Title: SolderingStation_Control.SchDoc

Size	Number	Revision
A4		3
Date:	7/11/2021	Sheet of
File:	Z:\Documents\...\SolderingStation_Control	SchDoc By:

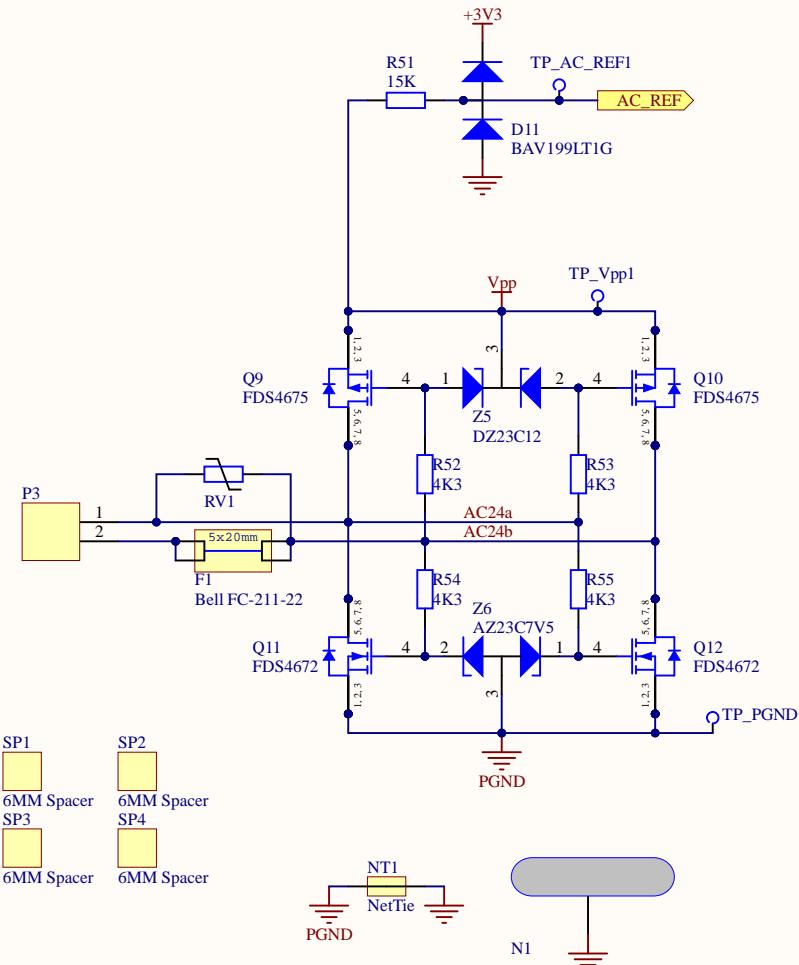
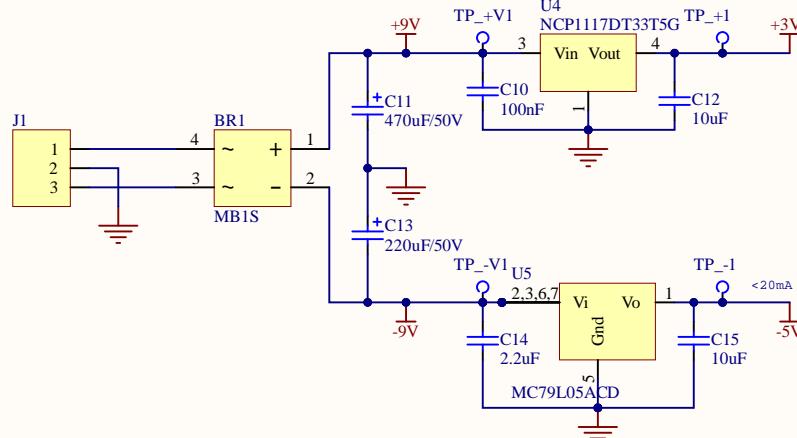
- Added Setback
- Changed current source IC etc.
- Added voltage reference for ADC

- Board Dimensions altered
- Simplified NTC cct. (linearity not required)
- Removed unused components
- Isolated thermocouple
- Isolated USB
- Prevented TC amp saturating
- Power LEDs directly driven
- Overcurrent directly measured
- Decoupled 3V3 supplies (noise from OLED)
